Scarlet Knitwears Ltd.

26 April 2014

Building Observations

Localised areas of high loading

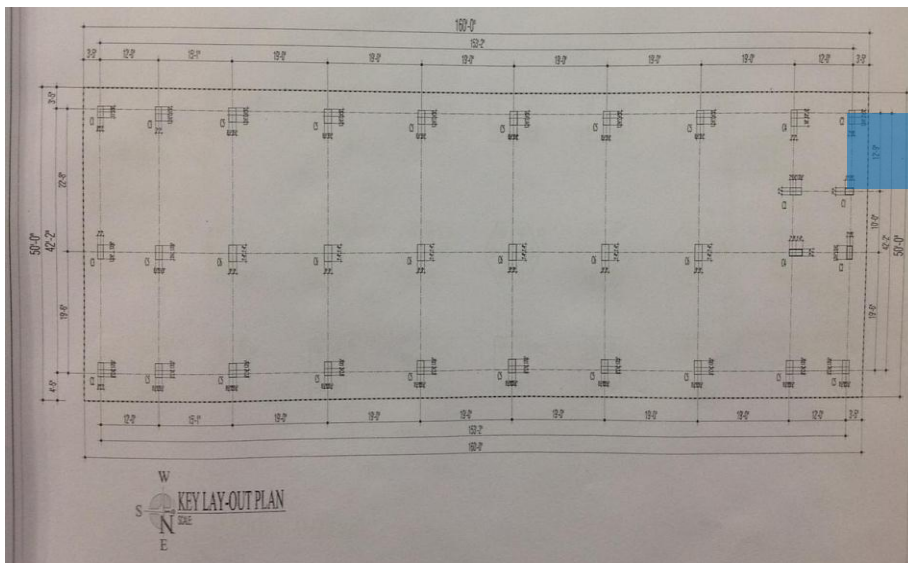
**Uncontrolled stacking
of materials.**

**Areas of high loading on suspended
structure. Floor load management
system incomplete as no loading plans
or loading height limits displayed.**

- Produce and actively manage a loading plan for all floor plates within the factory giving consideration to floor capacity and column capacity.
- Continue to implement load management plan

External Hoist

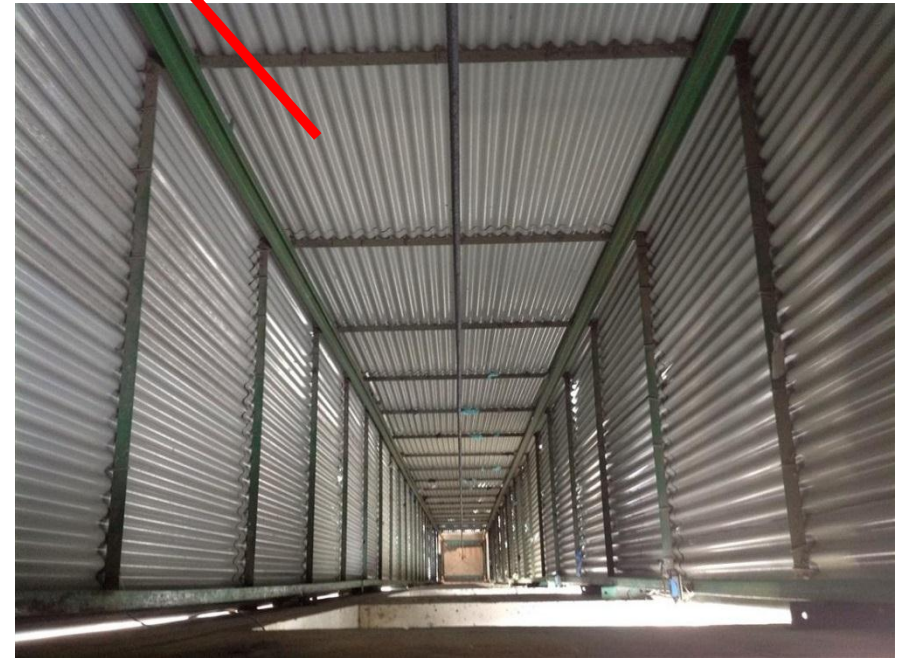
**Lateral stability of
external hoist surround
not apparent. Engineer
to review.**

- The stability of the surround to the external hoist should be reviewed by the Building Engineer and, if required, upgraded to support code vertical and wind loads or the assembly should be removed.

Structural Grid

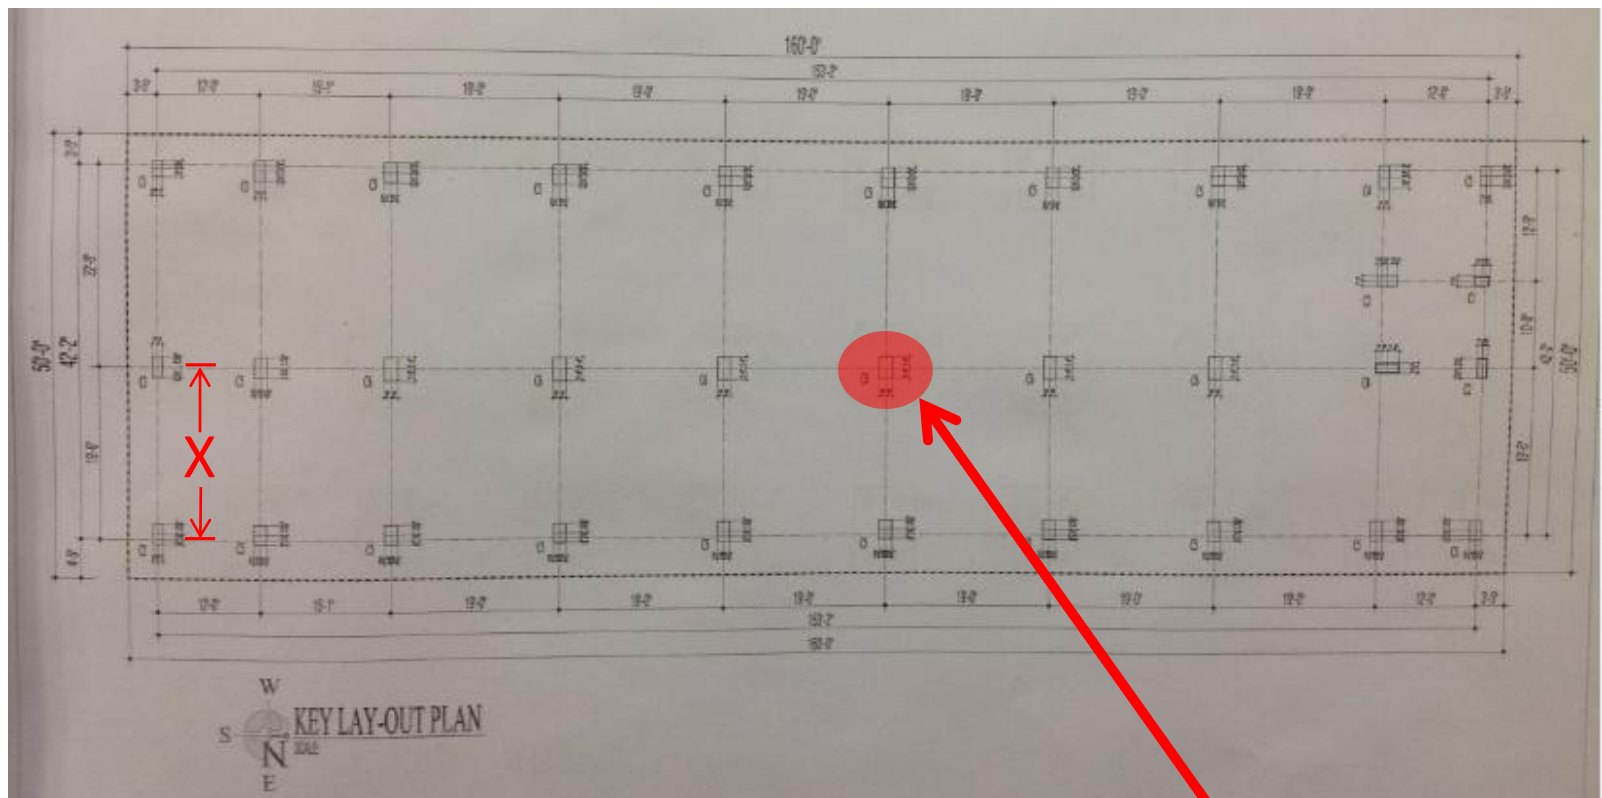
**Structural drawings not consistent with the
as-constructed arrangement of the factory**

There appeared to be a discrepancy in dimension "X" above.

Documented size $\approx 406 \times 762$ mm
Actual size $\approx 380 \times 762$ mm

Drawings are not as per the constructed building.

- Building Engineer to verify dimensions noted above and update drawings if required.
